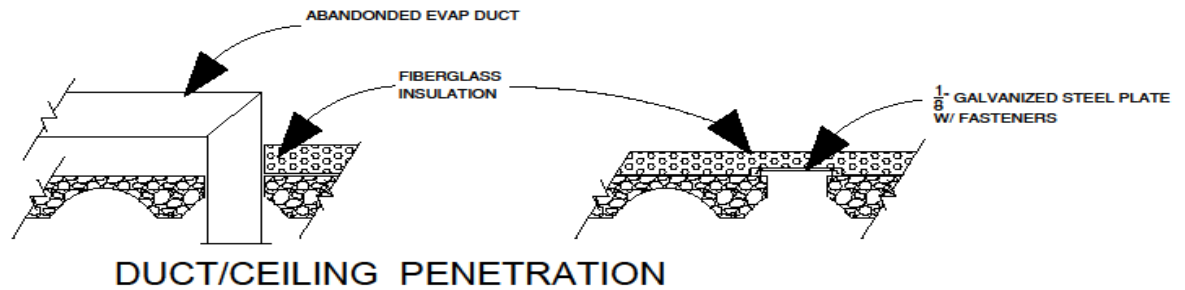
3. Can the Government provide a specification for the High Density Sound Blankets. Note I on Page

Fiberglass, STC 47

Smoke Developed 10

Flame spread 10

3 1/2" minimum
